TECHNICAL NOTE

Job Name: Land West of Park Farm, Thornbury
Job No: 39209
Note No: 39209/007
Date: 30 April 2020
Prepared By: K. Stock
Subject: **PT18/6450/O Land West of Park Farm, Thornbury – Response to SGC Comments dated 2nd April 2020**

Plate 10.1: Forecast School Trips at Butt Lane - SGC 80% Assumption (AM Peak = left, PM Peak = right)

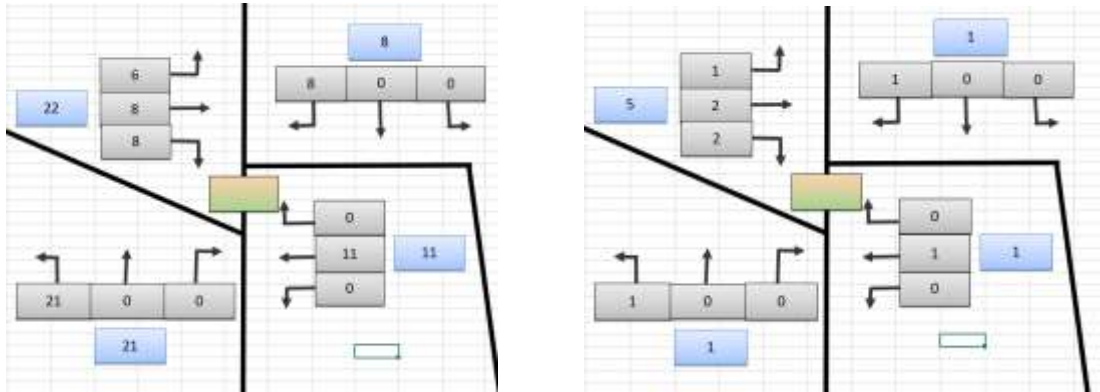
10.11. SGC has suggested that it could be assumed that 20% of vehicle trips are local to the development site and therefore not travelling through the Butt Lane junction as part of a school trip. Whilst Stantec consider that this is an overly robust assumption (see Para's 10.2 and 10.4 of this Note), this has been applied as a robust assessment of vehicular trips that could be associated with the school. The resultant vehicle trips are set out in **Table 10.2**.

- 10.13. [Table 10.2](#) and [Plate 10.1](#) demonstrate that the school could be associated with up to 52 two-way vehicle movements in the AM peak hour through the Butt Lane junction, equating to less than one additional vehicle per minute, on average.

- 10.14. However, as stated above, should the proposed school attract pupils from outside the immediate catchment, it must be the case that most of those trips will already be on the local highway network associated with other residential developments within Thornbury and will have been assessed through other planning applications. On this basis, there will already be a number of these trips passing through the Butt Lane junction associated with school trips elsewhere (either through observed surveys, or through our assessment as committed development trips). [Appendix D](#) demonstrates that vehicles routing from existing residential areas to the east of the Butt Lane junction would already be passing through the Butt Lane junction to reach other schools.

- 10.15. Therefore, it is considered that the actual number of new vehicle trips, not already accounted for within the modelling of the junction, will be significantly less, and negligible to the operation of the junction.

1:11,000 @ A3	Date: 30/04/2020
Drawn: IB	Checked: KS
Figure 10.1	Rev A

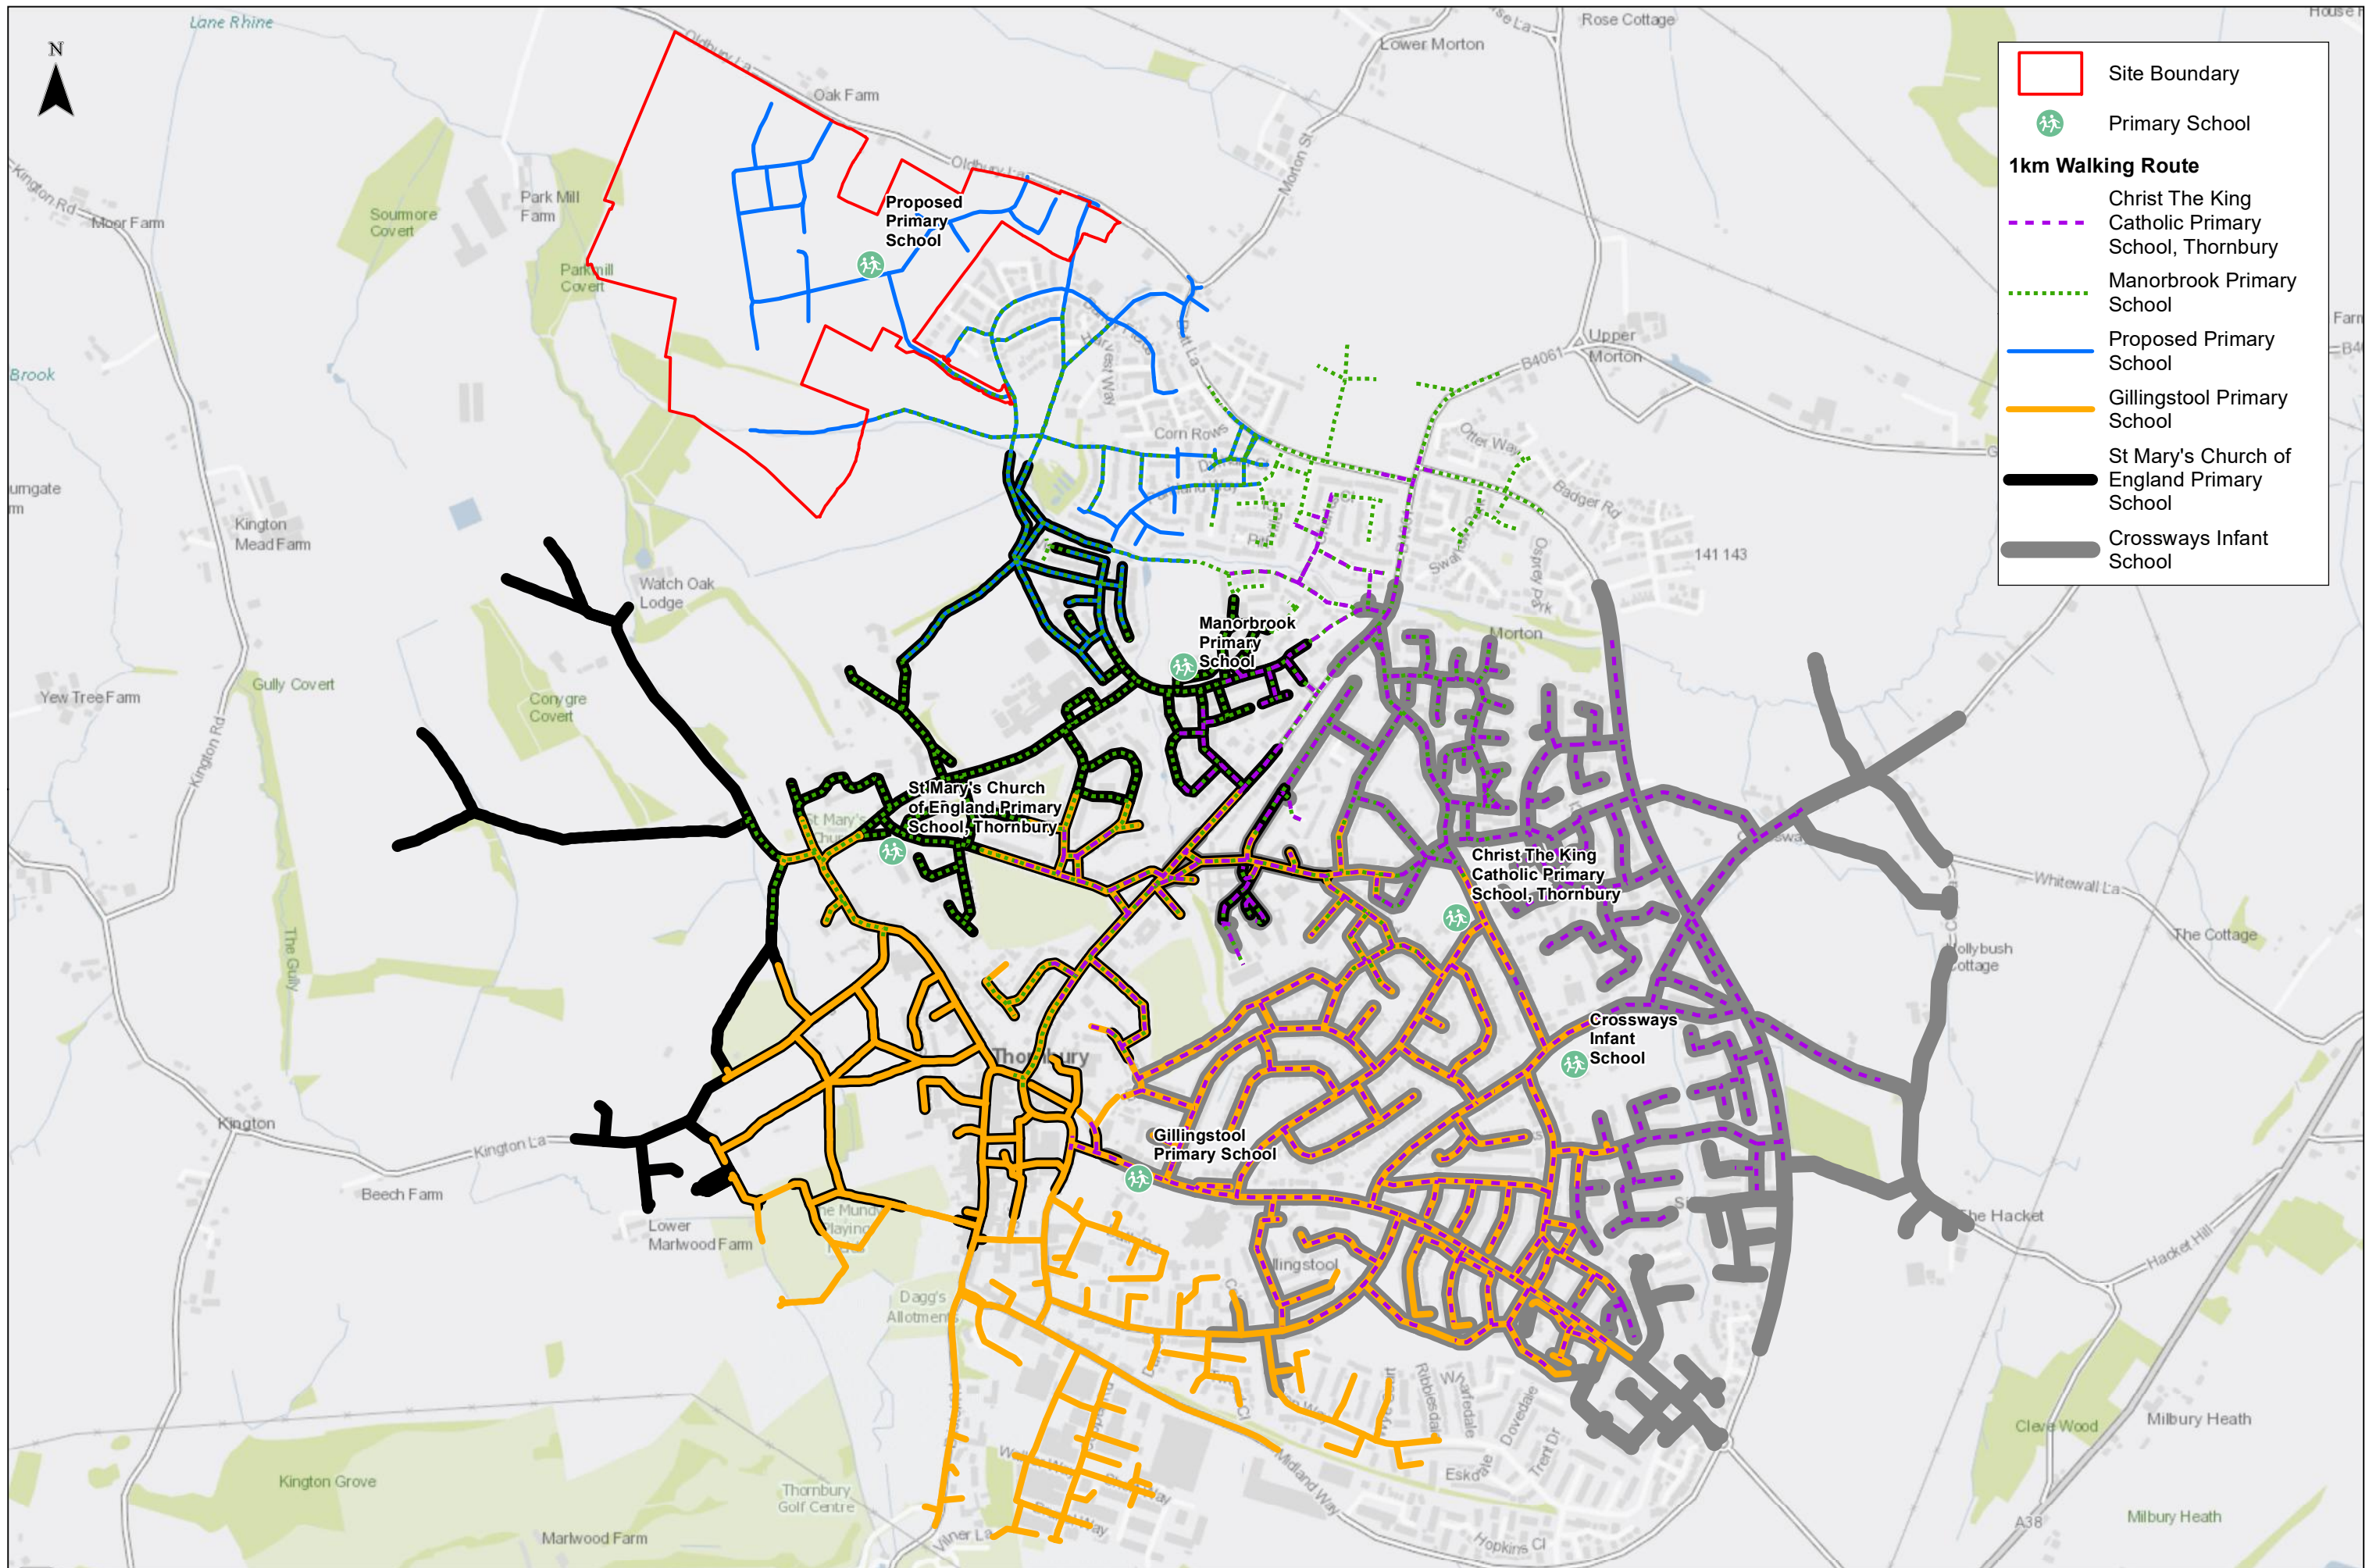
- 10.5. Whilst SGC did not formally comment on the approach set out in the previous TA, they have advised in their latest comments that "*the proposed vehicle trip rate reduction associated with the new school needs some further consideration*".

- 10.1. The updated planning submission includes land for a 1FE primary school and reduction of 35 dwellings.
- 10.2. Both the original TA (dated November 2018) and the updated TA set out an approach whereby there is a reduction in trips as a result of the proposed primary school due to the forecast high levels of internalisation. There are at least six existing primary schools within Thornbury and the majority of residential areas are within a 1km walking distance¹ of at least one of the existing or proposed schools, as shown on **Figure 10.1**. Whilst parents can choose which schools to send their children to, it is clear that the schools are located such that they serve a 'local' catchment and pupils can access them by non-car modes.

- 10.3. The proposed school could accommodate 210 pupils and it is estimated that 214 primary school age children could live within the development site itself. It is therefore considered that a high level of internalisation is probable, and / or pupils attending the school from the residential areas immediately adjacent to the development site.

- 10.4. The location of the proposed primary school, opposite the proposed STL, has also been chosen to maximise the accessibility by walking and cycling for residents within the site and immediate adjacent residential areas, to provide a real advantage over the private car for the significant majority of pupils and staff attending. In addition, the proposed bus stop immediately adjacent to the school, offers the opportunity of staff living further afield to travel to the school by means other than the private car from across Thornbury, along the A38 and through the North Fringe to central Bristol.

**LAND TO THE WEST OF PARK FARM
 THORNBURY
 M5 JUNCTION 14 MITIGATION SCHEME
 350m 2 LANE N/B OFFSLIP**

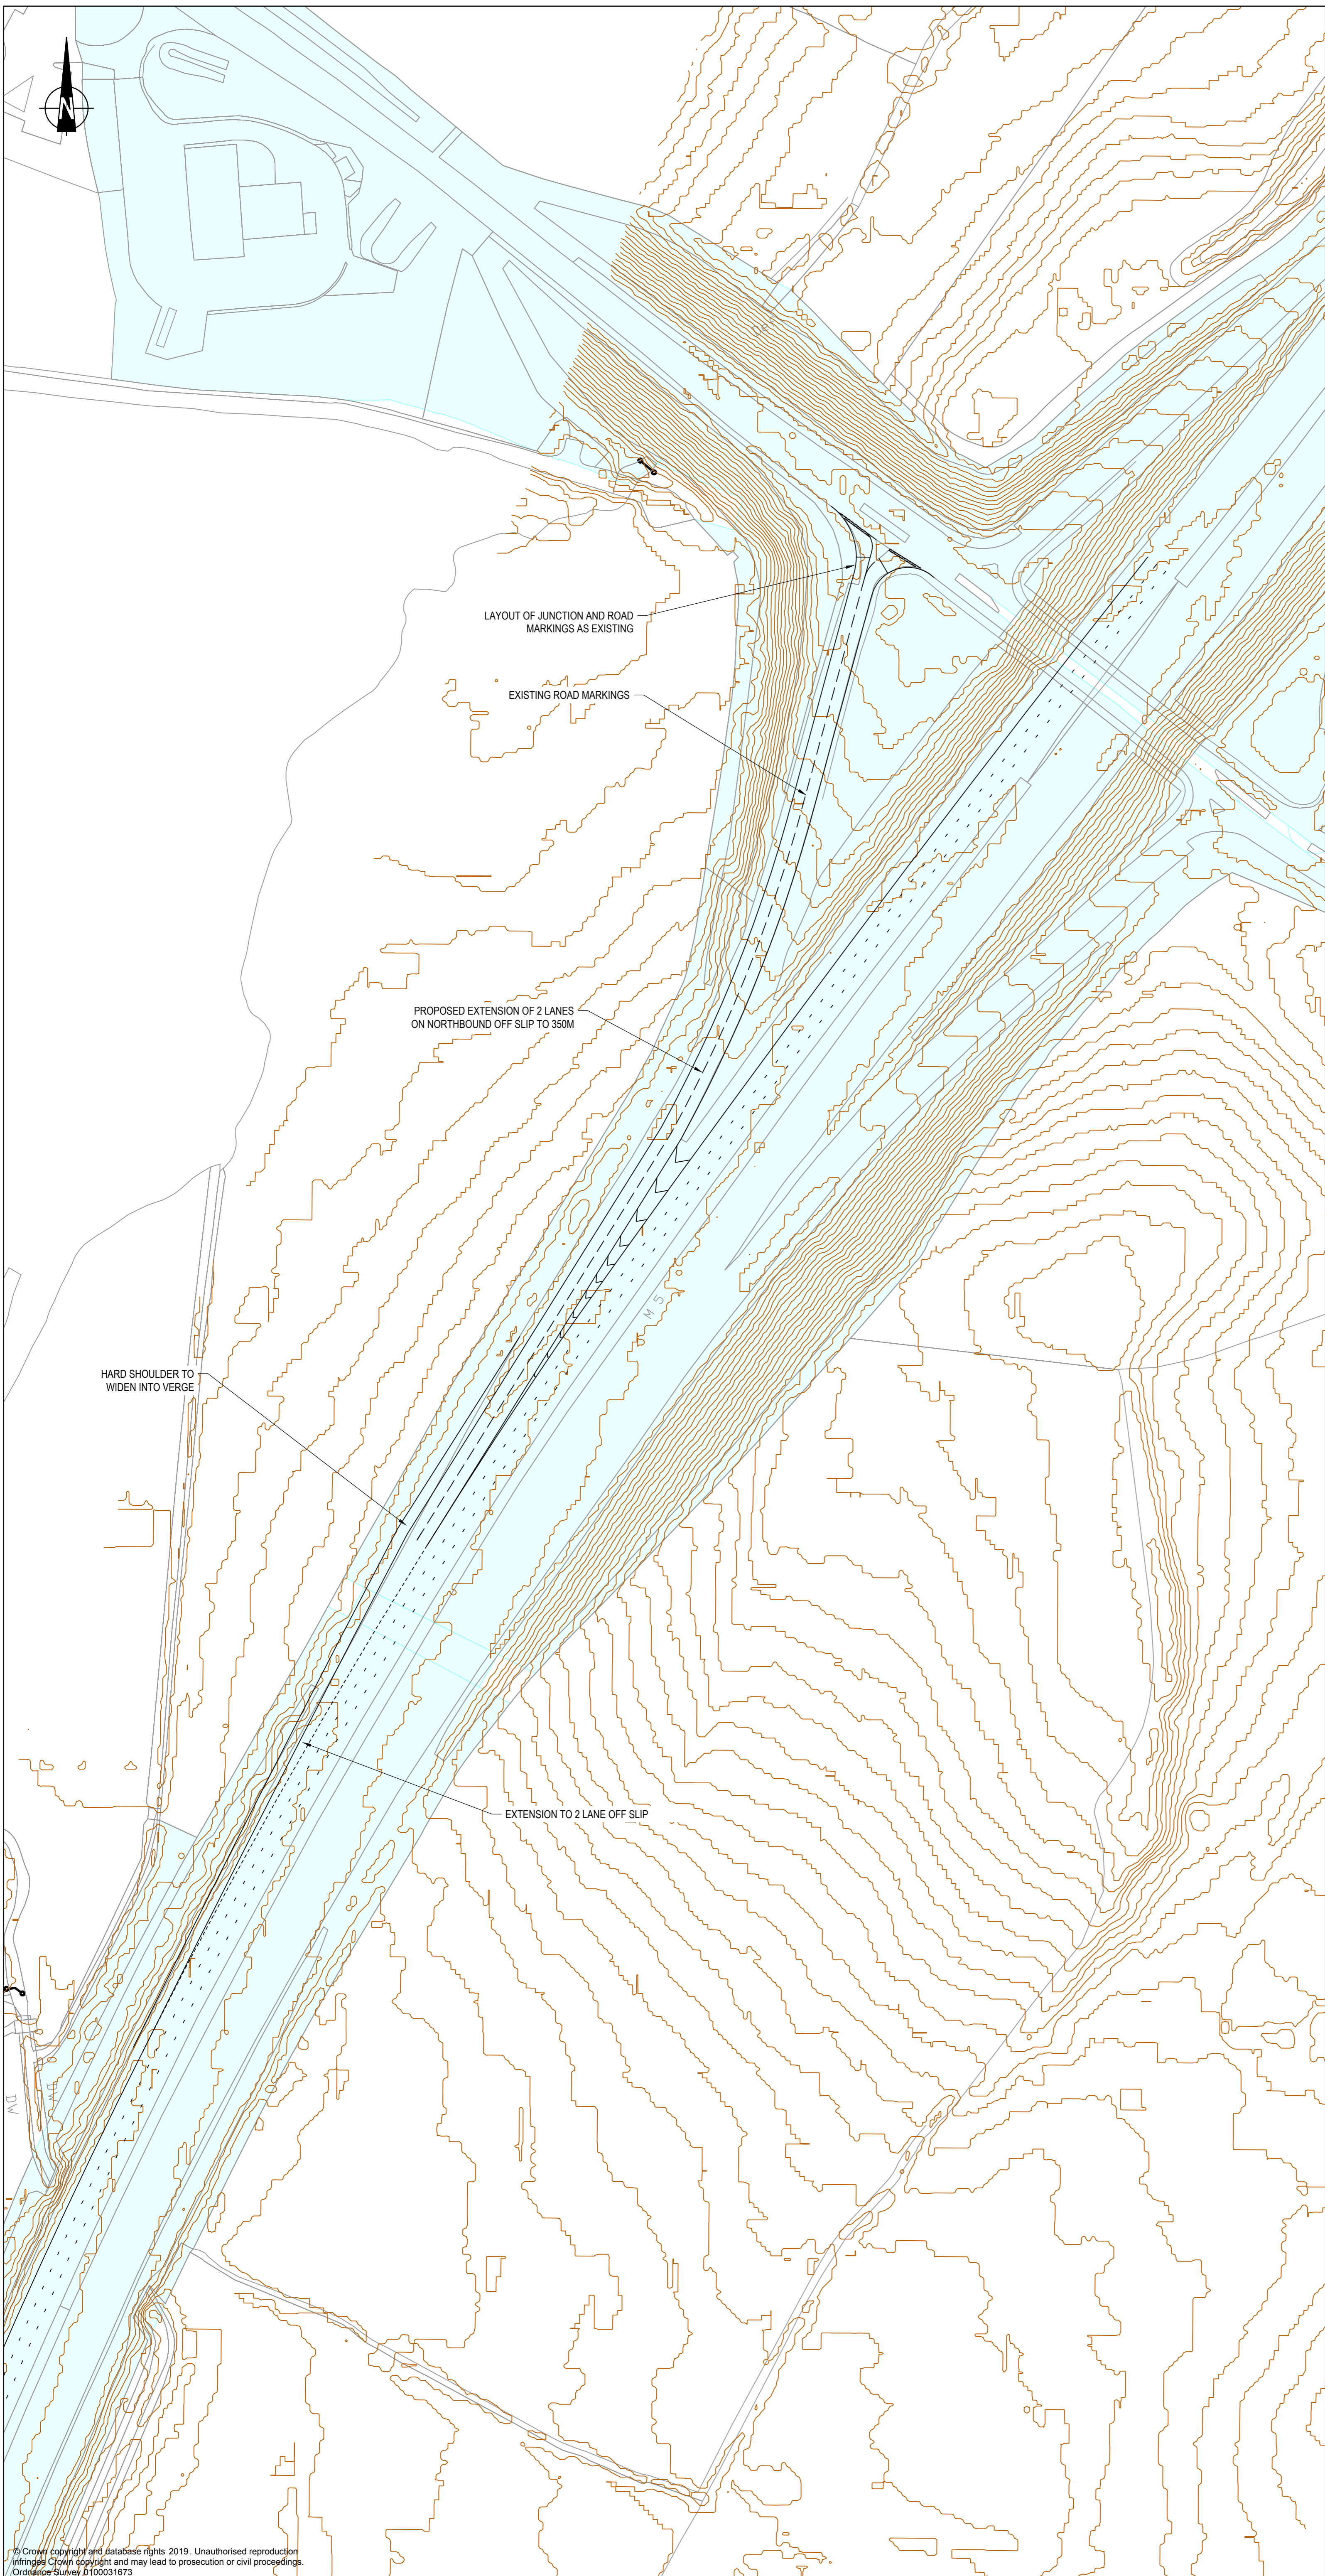
- 11.1. Following submission of the planning application, Highways England (HE) confirmed that mitigation is required to address the increase in queuing on the M5 northbound off-slip. Discussions have been ongoing with HE to confirm the mitigation required.

- 11.2. HE has confirmed that, in terms of design, the mitigation scheme proposed as part of the Development is considered to be suitable in principle, subject to a Stage 1 Road Safety Audit (RSA). However, HE identified additional queuing within the model on the A38, which is within the control of SGC, as a result of this proposed mitigation.

- 4.4. It is proposed to lengthen the two lanes on the off-slip to a total of 350m. A drawing of the scheme is provided within **Appendix A**.
- 4.5. HE has confirmed that, in terms of design, the mitigation scheme is believed to be suitable in principle, subject to a Stage 1 Road Safety Audit (RSA).
